Response to Submissions

Installation and Operation of a Crushing System at the Calga Sand Quarry

February 2017

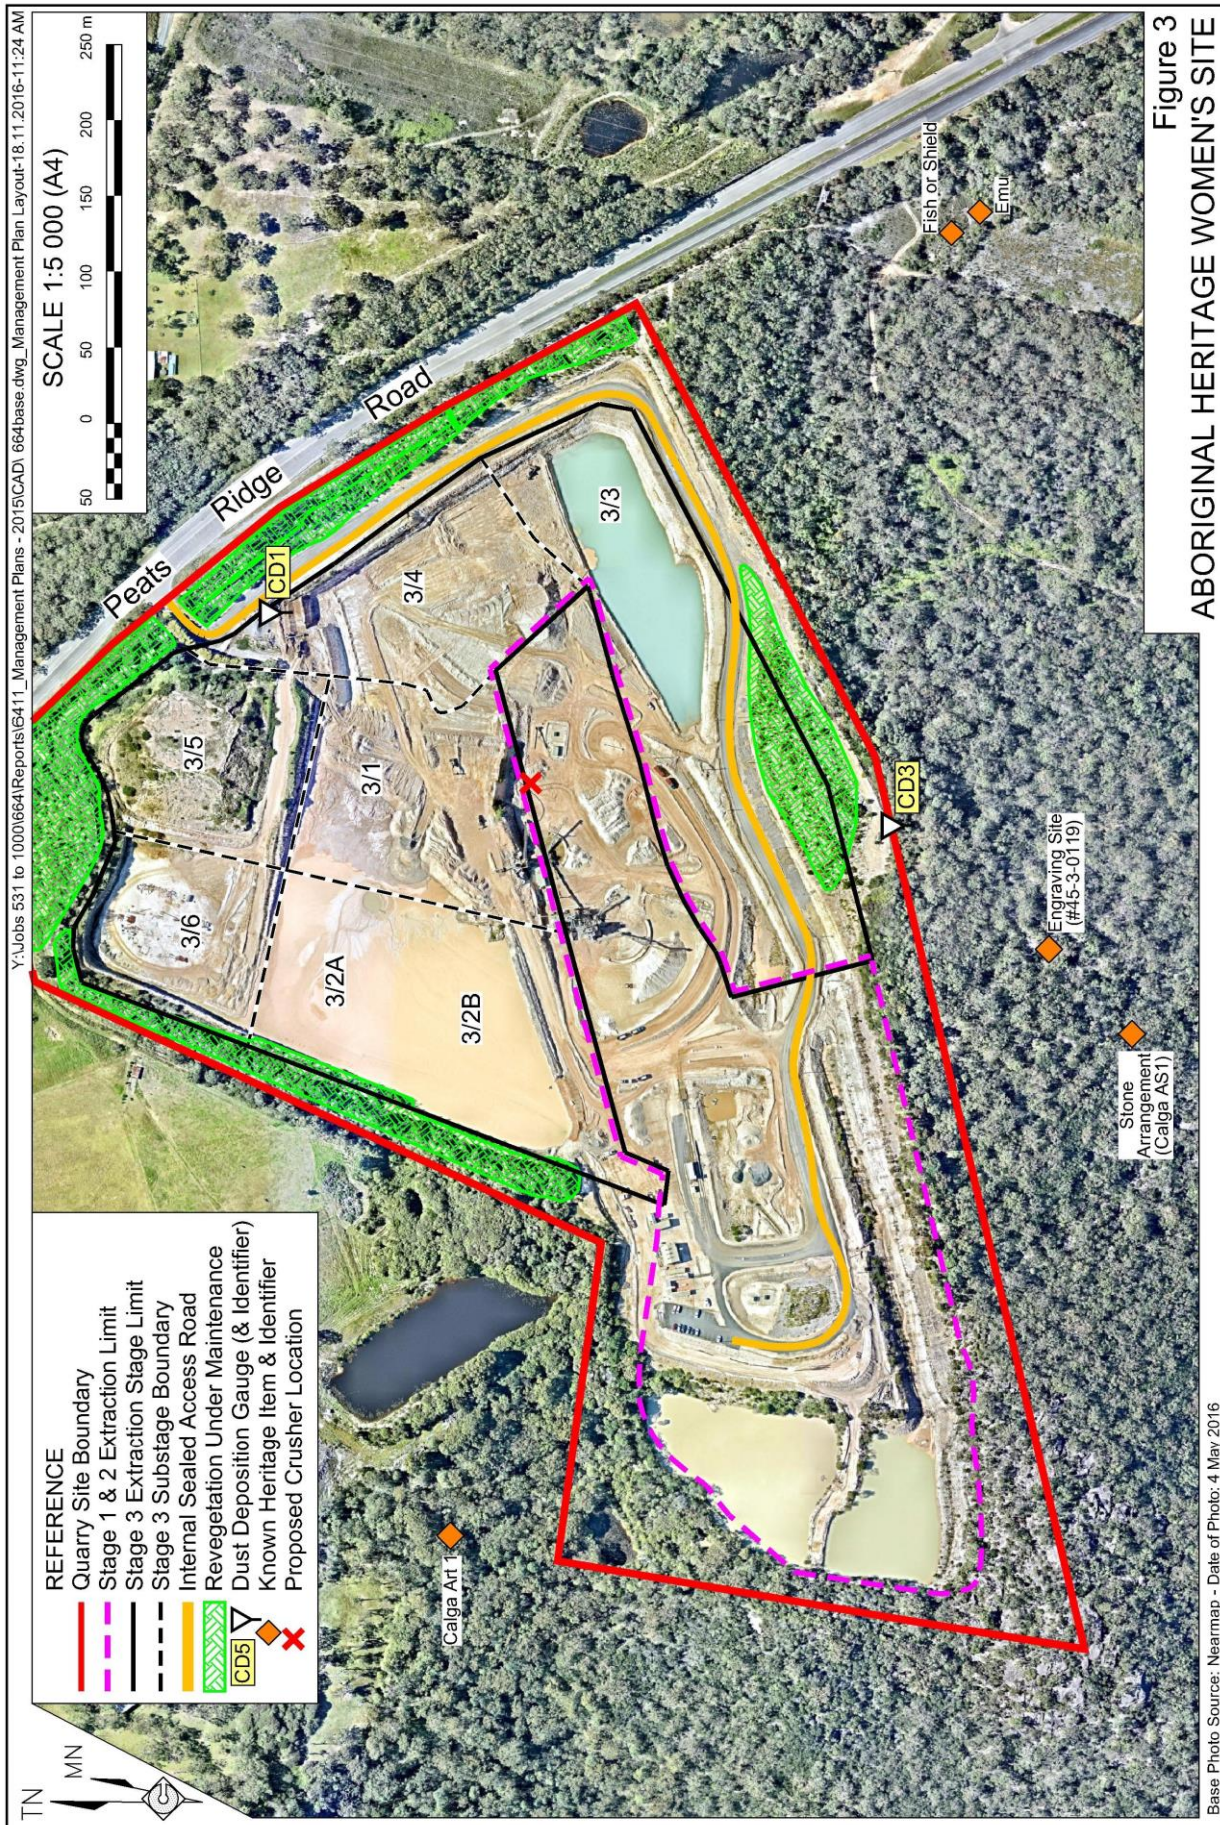
The EA has not considered the location of the quarry in relation to significant Aboriginal culture heritage sites. Provide further detail on the proximity of the crusher to these sites and an assessment of any impacts that may occur.

The EPA request that the proponent provide noise contours for the premises (or modelled results for the Aboriginal site) that are reflective of the predicted noise levels modelled in the 2015 NIA. Any assessment in this regard should compare predicted levels with the crusher (as proposed) to predicted levels in the absence of the crusher (status quo).

Figure 3 displays the location of the existing approved Quarry, the proposed location for the crushing system and the locations of the stone arrangement (Calga SA1) and rock engravings (AHIMS reference 45-3-00119 or 45-3-2195), collectively referred to as the 'Women's Site'. The rock engravings are considered in this response due to the proximity to the existing operation and the proposed crushing system (approximately 360m from the location of the crushing system). Compliance with the relevant criteria at this location is taken to infer compliance at the other known Aboriginal heritage sites in the vicinity of the Quarry.

As described in Section 3.2.2, Hanson is not in a position to confirm whether the Women's Site should be considered a sensitive receiver and makes no assertion on this matter. The Women's Site is displayed on **Figure 3** and the amended Noise and Vibration Assessment has considered noise levels at this location against the criteria presented in the INP for places of worship (i.e. 40dB(A)). In summary, the Women's Site has been assessed as though it were a sensitive receiver so that acoustic amenity at this location is considered. The results of this assessment are presented in Section 3.2.2 and the amended Noise and Vibration Assessment. Wilkinson Murray conclude that noise levels at the Women's Site are predicted to remain compliant with the assessment criteria for places of worship during operations incorporating the crushing system and note that noise levels are not predicted to change with and without the inclusion of the crushing system.

The location of the Women's Site Engravings (approximately 360m from the location of the crushing system) has been included as a 'sensitive receiver' in the noise modelling for the proposed modification. This location was chosen as the engravings are closer to the crushing system than the stone arrangement.

Figure 2 Stage 3 Approved Operations - Source Location

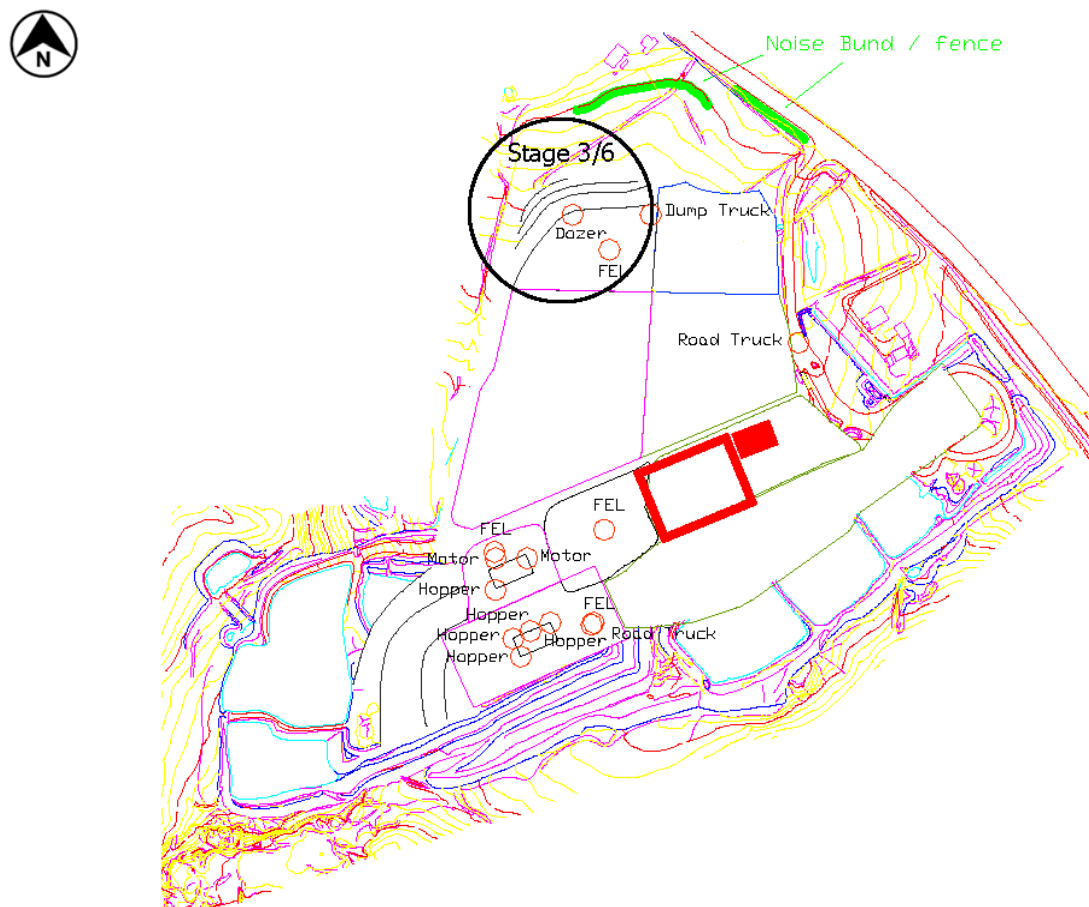
The NIA does not provide sufficient information regarding what scenario was modelled, including what quarrying activities were modelled, what meteorological conditions were modelled and which extraction areas in Stage 3 were assessed during the modelled scenario.

A section has been added to the amended Noise and Vibration Assessment (**Appendix 1**) that describes the modelling methods in detail and incorporates a scenario figure.

In summary, the modelling approach used existing modelling of approved extraction activities during Stage 3/6, indicative mobile equipment locations and the use of the processing facilities including the mortar sand plant and wash plant located to the south of Stage 3/2. The crushing system was modelled separately and the results of the approved activities and the stand alone results for the crushing system combined to produce predictions of noise levels at the nearest residences. Predictions were made during a range of meteorological conditions. For example, for daytime calculations, 41 separate conditions were considered, including wind speeds of 0.5-3m/s in each of eight directions, and zero wind speed (representing both zero wind and wind speeds above 3m/s). Noise levels were calculated under each of these conditions, and the probability of occurrence of each condition for the day period in each season was then used to calculate the L_{Aeq} noise level which would be exceeded for 10% of 15-minute periods.
